Model	N865 (VT21	05, Ges5325, Rex1250, NSA CF	> 325)				Volt/Hz	Date of Modification		erial mber
Мс	odified Article	Reverse Rol	ler Clutch								
Reason for Modification		To erase hor	rizontal white line in photo mode								
Draw No.	Old Parts No.	New Parts No.	Description	Rank	Q'ty Used Old \rightarrow New	Inter- change-	Part needed	for replaceme	ent by new part		arts talog
NO.	NO.	NO.			ability	Part No.	Description		No.	Page	
	C2168122	C2168123	Main Control Board - 230V		$1 \rightarrow 1$	O/O				31	67
	C2168112	C2168113	Main Control Board - 115V		$1 \rightarrow 1$	O/O				31	67
	C2158045	C2158057	IC - Main Board		$1 \rightarrow 1$	O/O				32	67

DETAILS OF MODIFICATION

MODIFICATION BULLETIN NO. 12 PAGE 1 OF 6

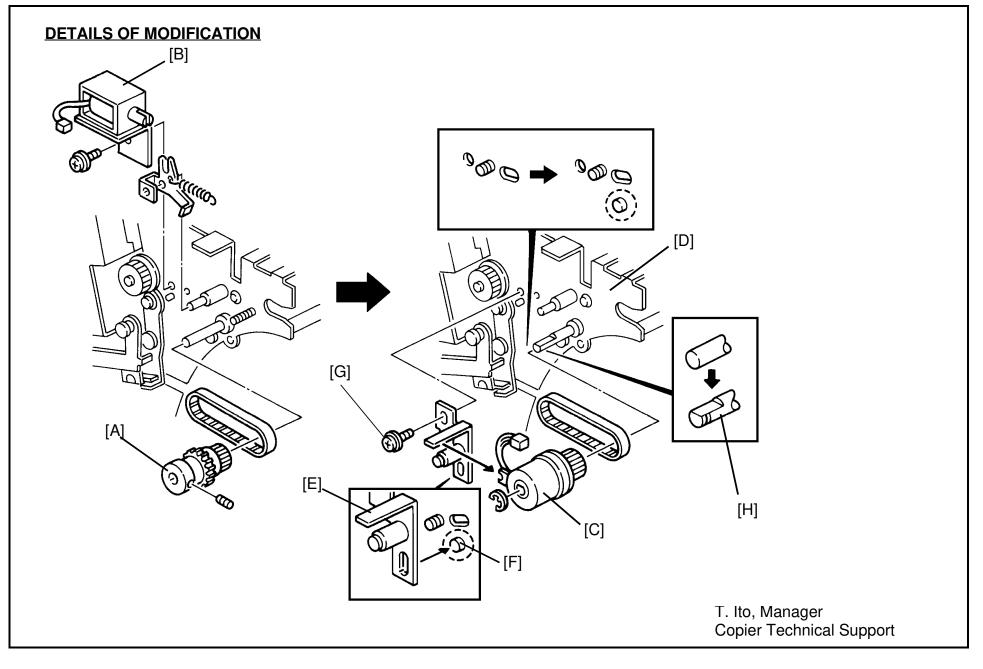
It has been found that a horizontal thin white line appears 64 mm from the leading edge of prints. The line may be visible when the image is made using the photo mode. This line is caused by a shock wave when the master is clamped by the drum master clamper.

1. To erase this white line, the software has been changed to delay the timing of the master clamping. With the old software, the reverse roller solenoid [A] and the master clamper solenoid were turned off at the same time. (Due to the slow response of the old spring clutch, the reverse roller stops feeding the master after the master was clamped.) The new software enables that the master is clamped when the master is fed 2 mm further after the reverse roller stops feeding the master. This allows to make a small buckle of the master, which absorbs the shock wave, between the platen roller and the reverse roller before the leading edge of the master is clamped.

2. To enable the proper reverse roller stop timing, the reverse roller clutch mechanism has been changed from the conbination of a solenoid [A] and a spring clutch [B] to an electrical clutch [C]. To cope with the strictly controlled reverse roller stop timing, the electrical clutch responds a little bit quicker than the old clutch mechanism. (If the old spring clutch is used, the only side effect is as mentioned above.)

To make assembly of the clutch stopper [E] in the factory easier, a projection [F] is added on the right side plate [D] (C2164005). Even if the side plate does not have this projection, the clutch stopper can be installed on the side plate with one screw [G] (09604008Z). So, the part number of the right side plate has not been changed. Also, the shape of the upper reverse roller shaft [H] has been changed to match the electrical clutch. The old spring clutch [B] can be replaced with the new electrical clutch [C] (C2158240) with the clutch stopper [G] (C2154200) and the upper reverse roller (C2154046).

The new ROM can be used also for existing machines. The only side effect is that the image on prints is forwarded about 1 or 2 mm due to the slow response of the old mechanism. (This value varies due to ratchets of the clutch gear.) If the old ROM is used for a modified machine (this is the same situation as the new clutch mechanism installed on the old machine), the image is shifted approximately 0.6 mm backwards.

5. All versions

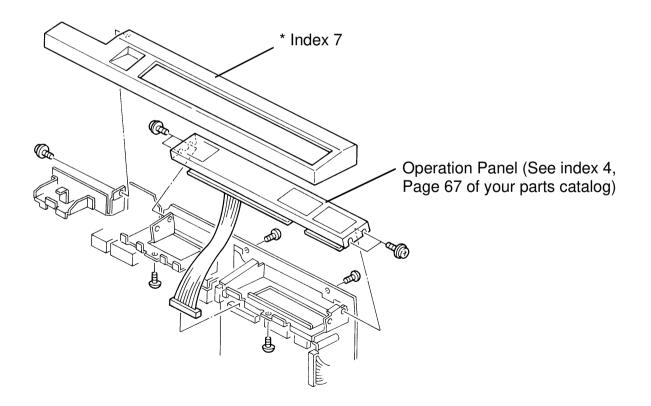
Correct the illustration in the EXTERIOR section as follows:

Page 59 PLOTTER / MASTER FEED SECTION 2

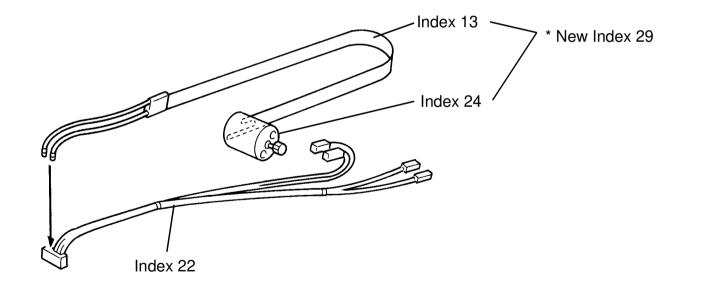
Add the following part and correct the illustration as shown below:

New Index No.	P/N	Description	Q'ty
29	C2008415	Motor / Cable Ass'y	1

* The motor (C2008418) and flat cable (C2008417) are soldered, and they are supplied also as an assembled part as shown below.

Page 61 PLOTTER / MASTER FEED SECTION 3

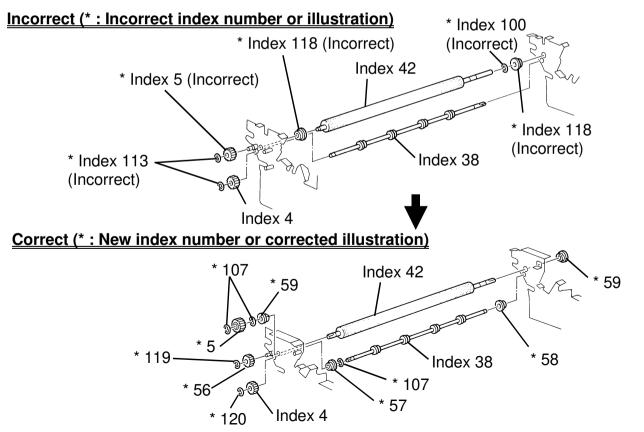
Add the following parts and correct the illustration as shown below:

New Index	P/N	Description	Q'ty
56	C2002338	Gear - 20T	1
57	53241658	Bushing - 4 x 8 x 4.5 mm	1
58	H0022226	Bushing - Head Roller	1
59	H0121181	Bushing - M6	2
119	07200020Z	Retaining Ring - M2	1
120	07200025Z	Retaining Ring - M2.5	1
